PMU-16

POWER MANAGEMENT UNIT

CHANGE LOG

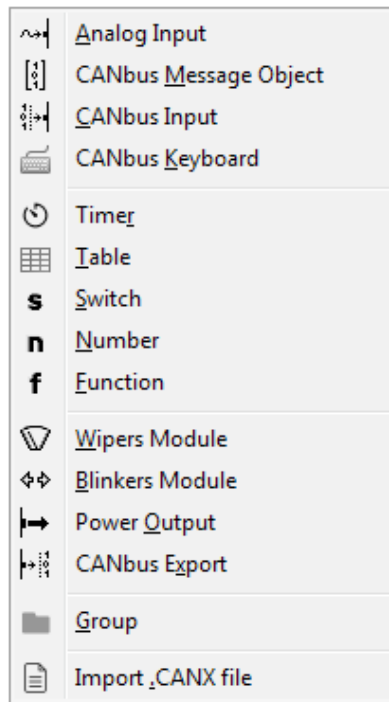
- Evaluation order of elements has been changed to reflect order in the Project Tree. Now the evaluation order is the same as in the ADU.

CANbus Keyboards
Tables
Analog Inputs
CANbus Mobs
CANbus Inputs
CANbus Keyboards
Timers
Tables
Switches
Numbers
Functions
Power Outputs
Switches
Wipers
Blinkers
Power Outputs
CANbus Exports
